Project	IEEE 802.16 Broadband Wireless Access Working Group < http://ieee802.org/16 >	
Title	Service Primitives for Location Update	
Date Submitted	2005-07-11	
Source(s)	Yun Won Chung, PhD Jee Hyeon Na, Sang Ho Lee, PhD ETRI, 161, Gajeong-dong, Yuseong-gu, Daejeon, 305-700, Korea	yun.chung@etri.re.kr jhna@etri.re.kr leesh@etri.re.kr Voice: +82-42-860-5244 Fax: +82-42-861-1966
Re:	Call for Comment on P802.16g Baseline Document	
Abstract	This contribution proposes service primitives for location update.	
Purpose	The document should be considered during the resolution of comments on the baseline document.	
Notice	This document has been prepared to assist IEEE 802.16. It is offered as a basis for discussion and is not binding on the contributing individual(s) or organization(s). The material in this document is subject to change in form and content after further study. The contributor(s) reserve(s) the right to add, amend or withdraw material contained herein.

Service Primitives for Location Update

Fig. 2 - Location Update Primitives

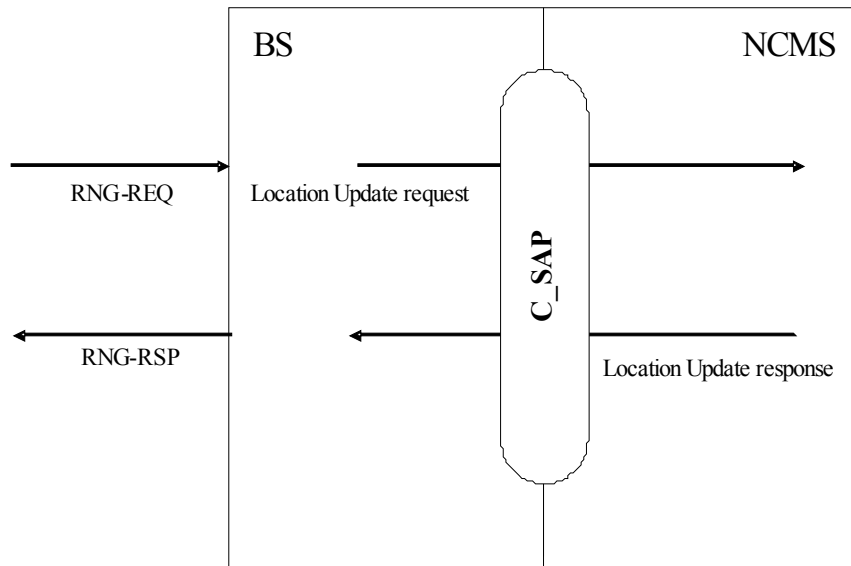
[Modify section 14.5.9.3 as follow]

Figure 2 shows service primitives for Location Update between a BS and an NCMS.
